## PERMIT APPLICATION REPORT

Type of License: SIDEWALK CAFE PERMIT

Name of Applicant: Tanya Abraham d/b/a The Madrona Tree

Address: 315 Broadway

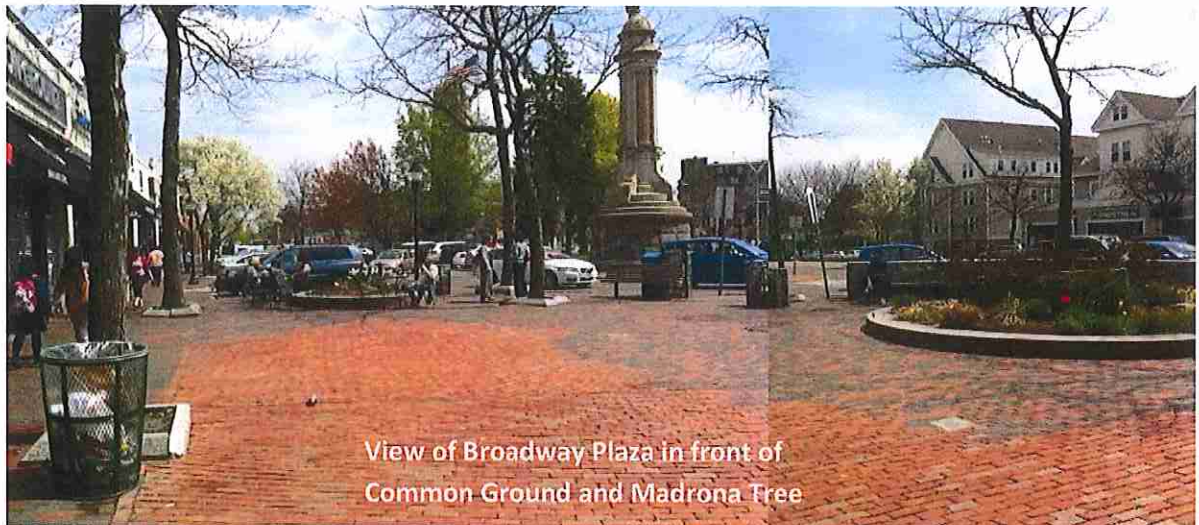
Common Ground has submitted an application, and the Department sent its Inspection Report on April 17. Madrona Tree is expected to soon submit an application. Economic Development Planner Ted Fields discussed with Madrona Tree their intended location for outdoor tables. The distance between fixtures installed in the Plaza was measured. To accommodate both restaurants, I recommend that Common Ground's outdoor seating area enclosure and planters be located not closer than 8 feet from the granite planter in front of the Madrona Tree (see photo below).

Correspondingly, I recommend that the seating area for Common Ground be allowed to extend beyond the west edge of the restaurant façade (i.e., extend in front of CVS by 8-10').
